DOCUMENTATION OF REVIEW FINDINGS

HQUSACE, Office of Water Project Review

**AMERICAN RIVER WATERSHED, COMMON FEATURES PROJECT
INTERIM GRR**

Final Integrated Feasibility Report and Environmental Impact Statement

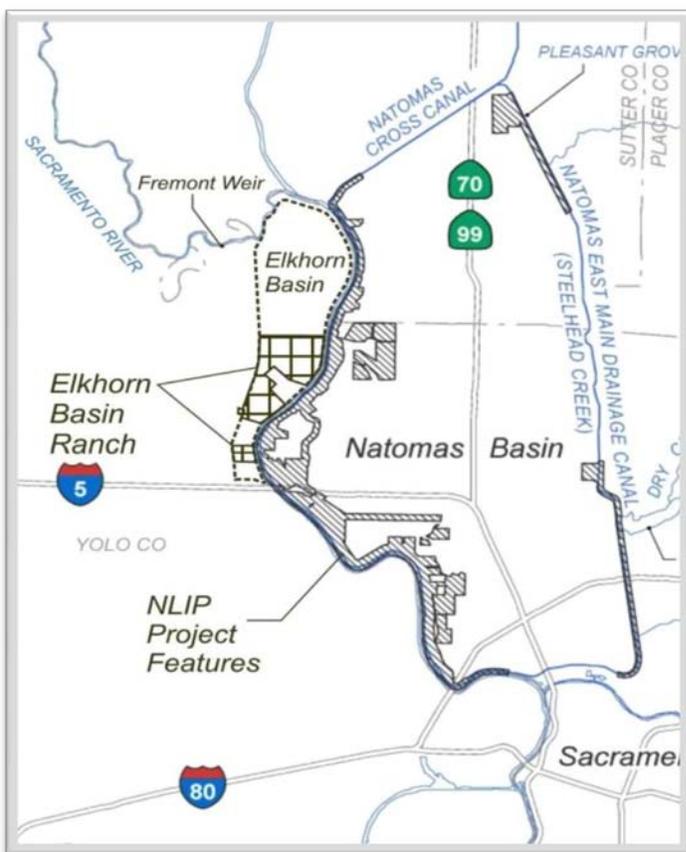
21. Plan Formulation and Residual Risk: Since this study is focused on flood damage reduction, it will need to comply with WRDA 2007, Section 2033. This requires a feasibility study for a flood damage reduction project to include, as part of the cost/benefit calculation, calculations: (1) of the residual risk of flooding, of loss of human life, and to human safety following completion of the proposed project; (2) of any upstream or downstream impacts; and (3) to ensure that the benefits and costs associated with structural and nonstructural alternatives are evaluated in an equitable manner.

HQUSACE Assessment: The concern is partially resolved: In the draft Final Report Residual risk of flooding is discussed in Chapter 4 as noted above, however, other actions are being taken by SAFCA to address residual risk. Those actions need to be described more fully.

Action Required: This discussion on residual risk has been added to the draft Final Report in Chapter 4, Section 4-12. Potential loss of life is discussed in Section 4-13.f. and Table 4-6. Upstream and downstream impacts are discussed in Chapter 4, Section 4-14.

Action Required: Add a graphic showing levee superiority considerations including location of Elkhorn that will be considered in the GRR but actions SAFCA has already initiated under expanded jurisdictional powers granted by the CA legislature.

Figure 4-1. Levee Cross-Section Showing Federal Plan

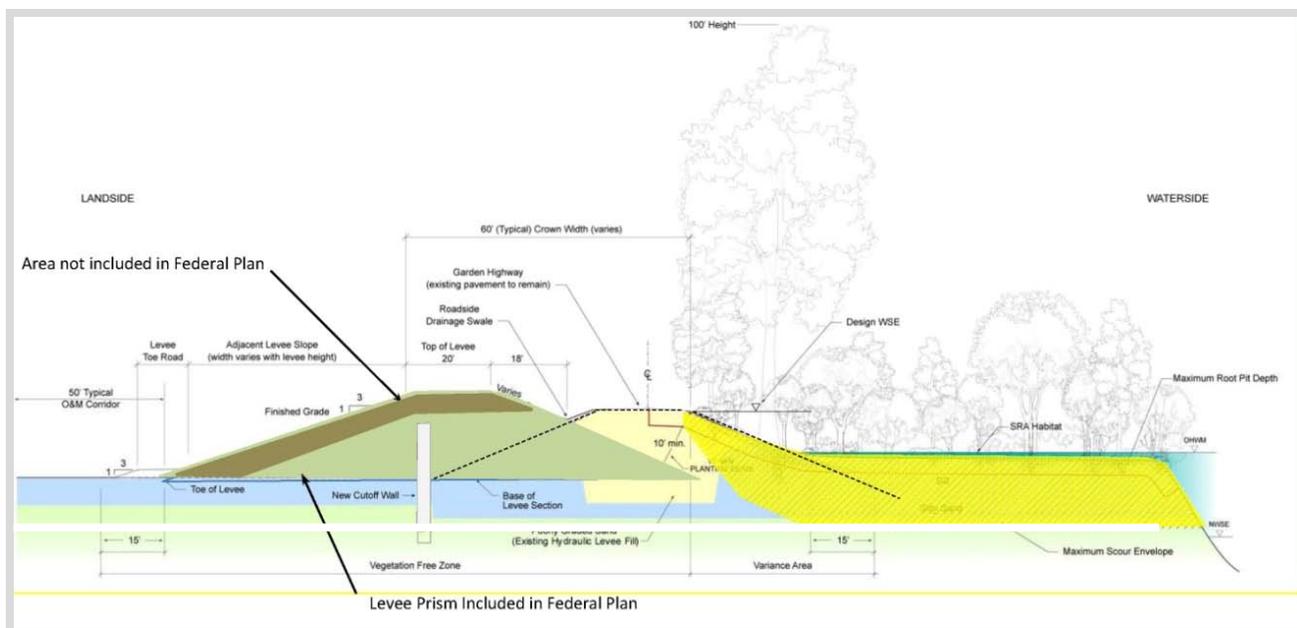
8. Description of Project Features for Recommended Plan: The recommendation section should be revised to include a complete description of the features that are included in the project (see example in ER 1105-2-100, Exhibit H-9). The existing recommendation does not contain any project-specific information other than a summary of costs and cost-sharing.

Figure 4-1 below shows the levee cross-section, and what part of it is constitutes the Recommended Plan, and what part is not included in it.

HQUSACE Assessment: The concern is resolved in the Final Report. See attached Figure 4-1.

Figure 4-1. Levee Cross-Section Showing Federal Plan

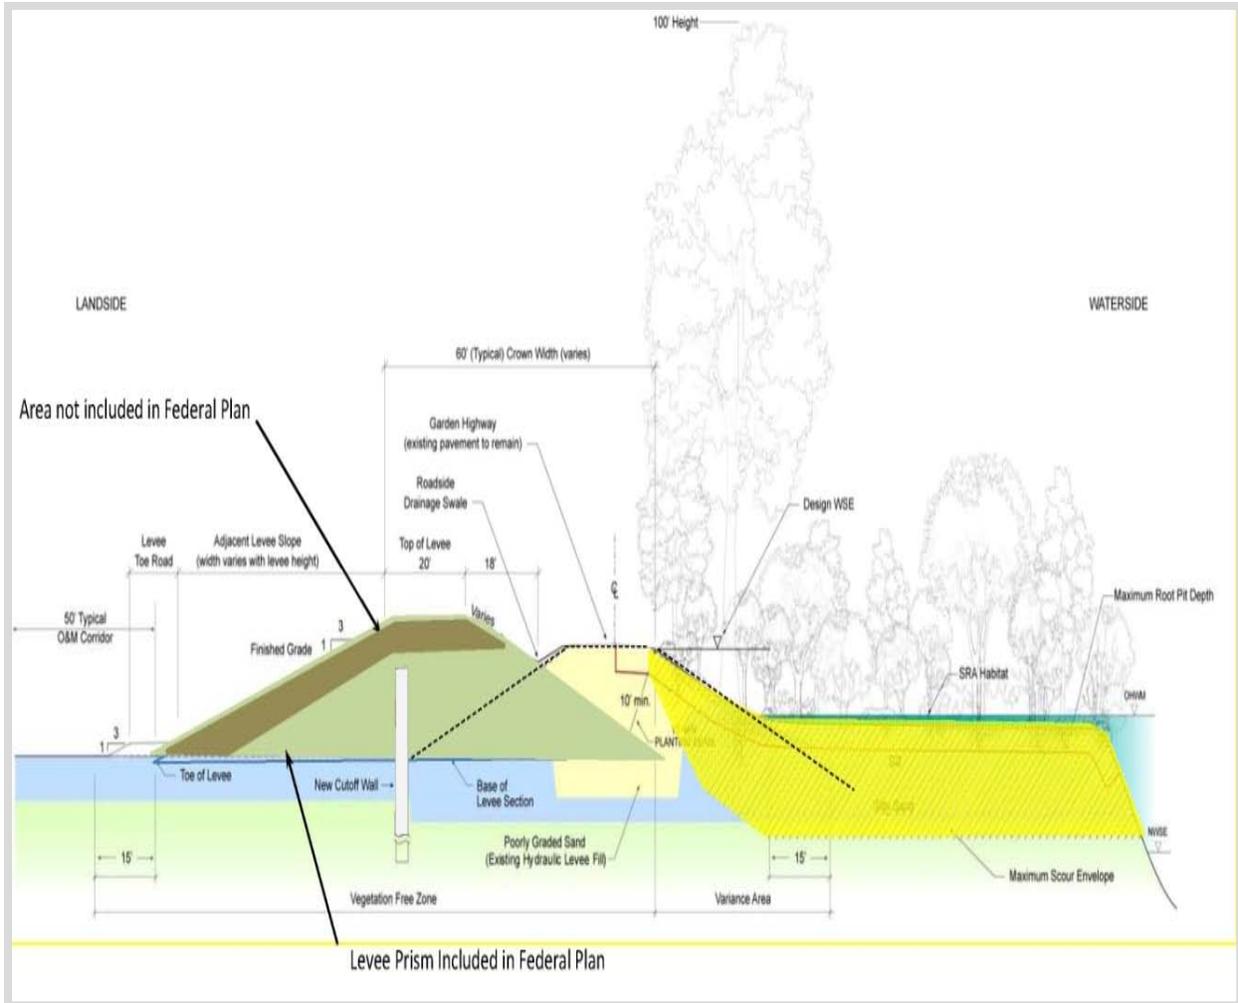
Those changes were made after the CWRB to the August Draft Final Report and the report was released to State and Agency Review. The 30-day review period ended on 22 November 2010.

During the S&A review, the District updated all costs and benefits to October 2010 levels. Due to the number of updates, not the significance, a Final Report dated December 2010 was published that included all of the previous changes included prior to the S&A release August Draft Final Report as well as the updated October 2010 costs and benefits.
